Stormwater Assessment for Rezoning

For:	Gainsplay Pty Ltd
By:	Wade Fletcher – CivilTech Consulting Engineers
Project Name:	Proposed Rezoning of Lot 32 DP 1169053 at Tuckeroo Ave, Mullumbimby
Date:	16 January 2026
Our Reference:	1002-32 – Stormwater Assessment – Issue A – 16.01.2026

Re: Response to Byron Shire Council Stormwater Comments

Planning Proposal for Rezoning of Lot 32 DP 1169053, Tuckerroo Avenue

Figure 2 – Stormwater catchment areas

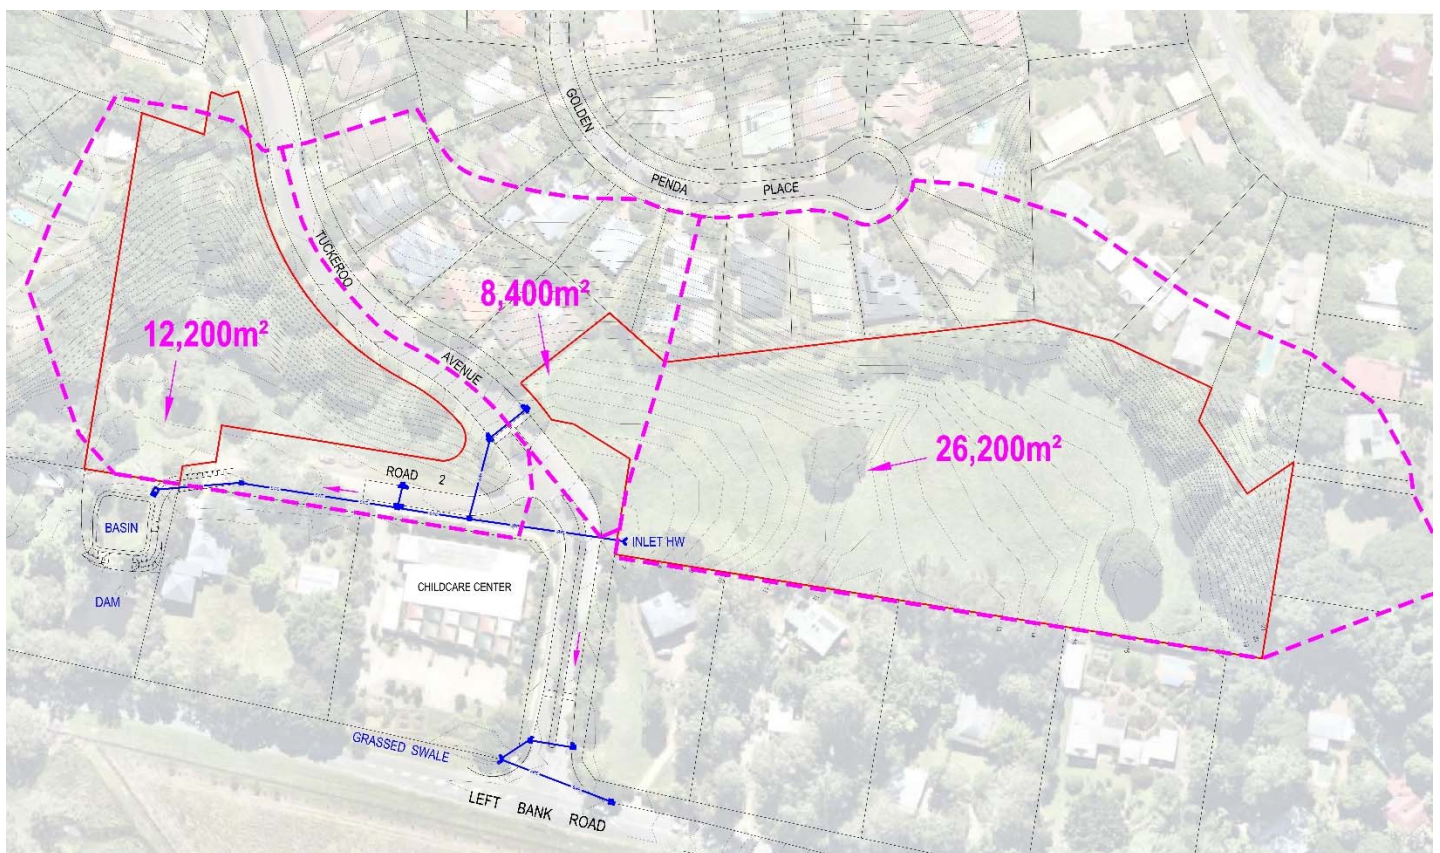
Point 1 – Legal Point of Discharge – Major System Criteria

Figure 2 of the Stormwater Assessment identifies the three principal catchments and their respective discharge points. All three catchments ultimately discharge via the existing stormwater pipe network to the detention basin located within Lot 1 DP 1007401. This basin is situated within a 30-metre-wide easement for stormwater detention created by DP 649971 for the benefit of Byron Shire Council.

For the eastern catchments of approximately 8,400 m² and 26,200 m², major storm events may result in bypass flows exceeding the capacity of the existing inlet pits identified in Figure 2 of the Stormwater Assessment. The legal point of discharge for these catchments is Tuckeroo Avenue, with flows continuing south to the flood storage area on Left Bank Road. Preliminary assessment of the 100-year ARI flows indicates that bypass flows remain contained within the Tuckeroo Avenue road reserve.

Point 2 – Road Drainage – Minor system criteria

Further investigations have been undertaken to assess the capacity of the existing pipe network shown in Figure 2 of the Stormwater Assessment.

The legal point of discharge for the western catchment, which has an area of approximately 12,200 m², is the existing detention basin within Lot 1 DP 1007401.

An inter-allotment drainage system is anticipated along the western boundary of the subject site to collect roof and surface runoff and convey flows to the proposed basin. No additional easements are required for major system flows.

The principal eastern catchment, with an area of approximately 26,200 m², drains to an existing 1200 mm x 1200 mm field inlet pit adjacent to Tuckeroo Avenue. The catchment is conveyed via an existing drainage gully traversing Lot 32 (Photo 1). Existing catchment flows

have been calculated as approximately 700 L/s for the 5-year ARI event and 1,380 L/s for the 100-year ARI event.

Allowing for a 50% blockage factor and a maximum ponding depth of 200 mm, the inlet capacity of the field inlet pit is approximately 700 L/s. Site inspections identified an actual ponding depth of approximately 500 mm, indicating an inlet capacity that exceeds the 5-year ARI event flow.

The concrete lid of the existing kerb inlet pit was removed during inspection and the connecting stormwater pipe was measured and confirmed to be 675 mm in diameter (Photo 2). The pit is approximately 1.35 metres deep and the outlet pipe has an estimated longitudinal grade of 2.0%.

At the calculated 5-year ARI flow rate of 700 L/s, the 675 mm pipe would operate at approximately 50% capacity. As identified in the previous report, the downstream outlet pipes comprise twin 900 mm diameter conduits. Their available capacity indicates that the existing underground drainage network has sufficient capacity relative to current design standards.

Based on these observations, the existing drainage network appears to satisfy the objectives of NRLG D5.09, including requirements relating to flow widths, pipe sizing, and minimum and maximum pipe velocities. Any future development will be required to ensure that post-development flows do not exceed existing pre-development flows, thereby maintaining compliance with these objectives.

Figure 3 –Zoning Plan with conceptual lot & unit layout (Low density in green, medium density in pink)

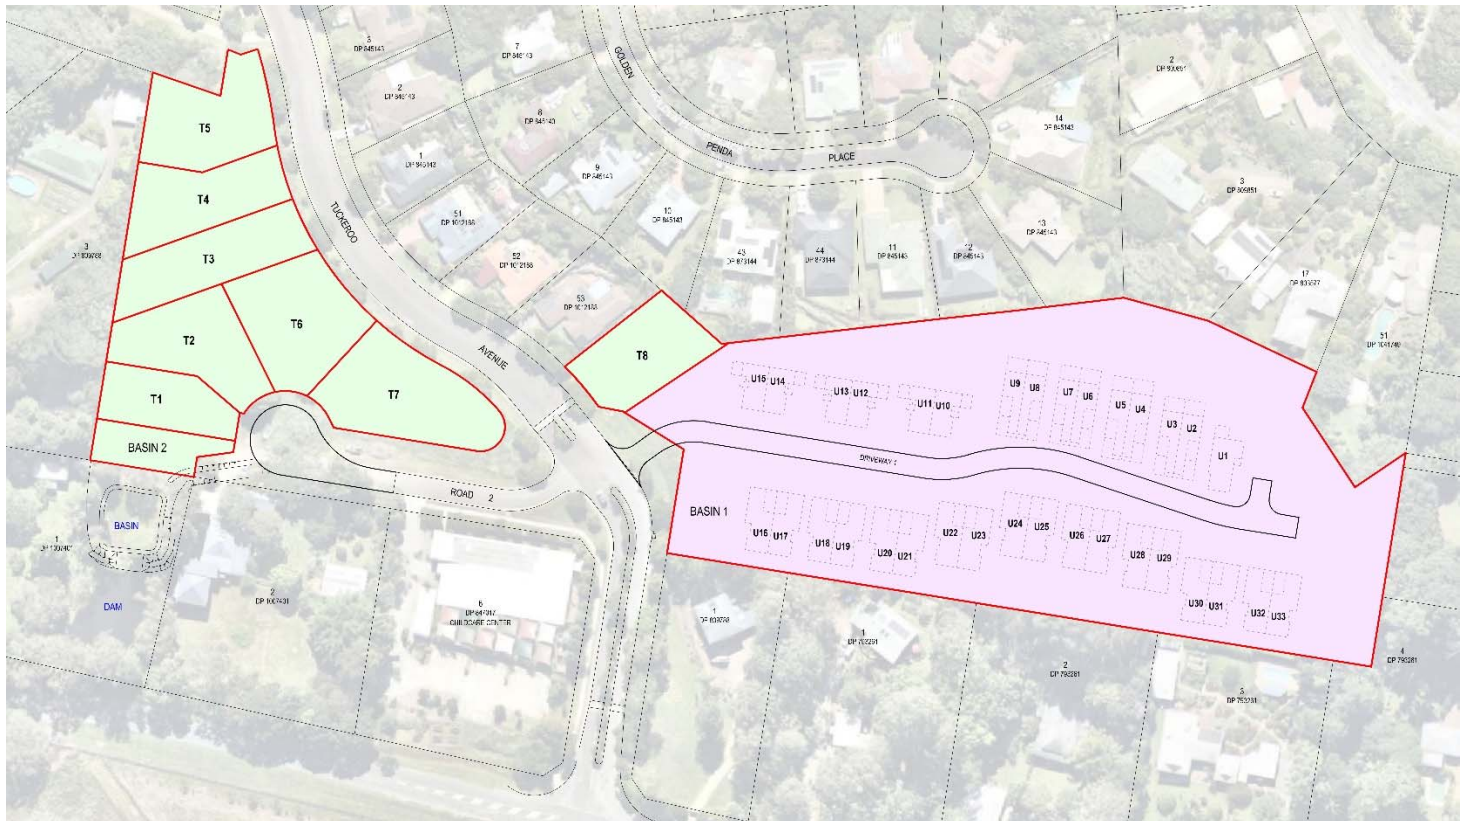
Point 3 – Stormwater Quality

Stormwater runoff from the western low-density Torrens title lots is proposed to be treated via a traditional bio-retention basin (Basin 2) located within a drainage reserve in the south-western corner of the site. The drainage reserve will be dedicated to Byron Shire Council for ownership and maintenance.

The conceptual drainage reserve has an area of approximately 400 m². It is anticipated that the basin will incorporate block retaining walls along the lower boundary, rather than earthen embankments, to provide sufficient treatment area and storage volume.

The total catchment contributing to Basin 2 is approximately 12,200 m², with a development area of approximately 7,500 m². Based on the deemed-to-comply provisions of the Queensland Urban Stormwater Quality Planning Guidelines (2009), the basin would require approximately 120 m² of filter media area and approximately 40 m³ of detention storage. Basin 2 will include a maintenance access track from the Road 2 cul-de-sac, together with a sediment forebay and gross pollutant trap consistent with other local subdivision developments.

The eastern catchment contributing to Basin 1 is approximately 26,200 m², with an anticipated development area of approximately 15,500 m². Under deemed-to-comply provisions, sufficient area exists to accommodate approximately 230 m² of filter media and approximately 80 m³ of detention storage within a traditional bio-retention basin.

As discussed with Mr Solatan, treatment and detention infrastructure associated with Basin 1 will be privately owned and maintained by the future body corporate. To minimise maintenance requirements and maximise opportunities for ancillary uses such as additional bin storage and parking, a proprietary treatment train is likely to be adopted in lieu of a traditional bio-retention basin.

Figure 4 – North Byron 2020 – 100 year 2100 Climate Change Hazard

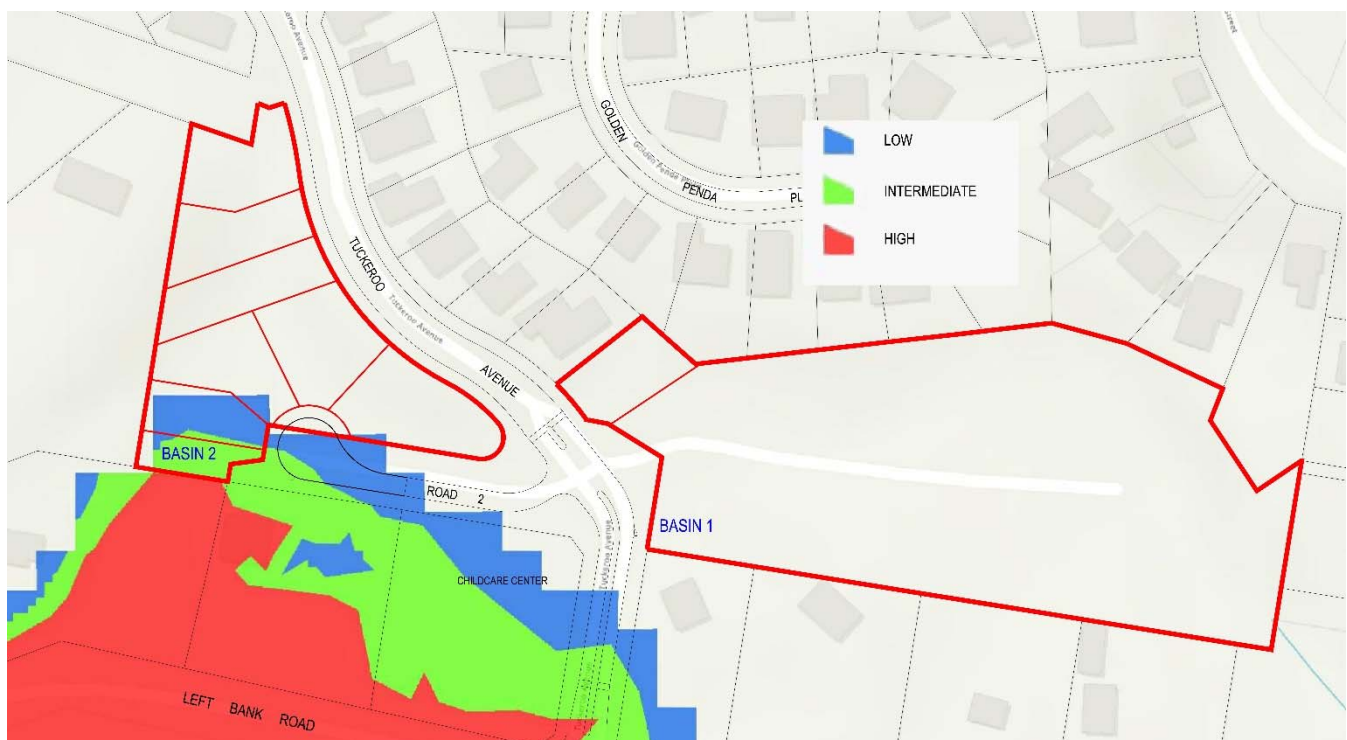
Flooding

Byron Shire Council's comments regarding flooding are consistent with the preliminary assessment undertaken by CivilTech.

Although Council's 100-year ARI, 2100 climate change flood mapping identifies flooding within the south-western corner of the site, the extent of inundation is relatively minor and no Fill Exclusion Zone applies to the subject land.

As part of any future Development Application, a detailed flood study and report will be prepared in conjunction with the detailed design of the proposed lots and drainage basins. This assessment will confirm that the development does not adversely impact neighbouring properties, that suitable flood-free access is maintained, and that all building envelopes are located at or above the required Flood Planning Level.
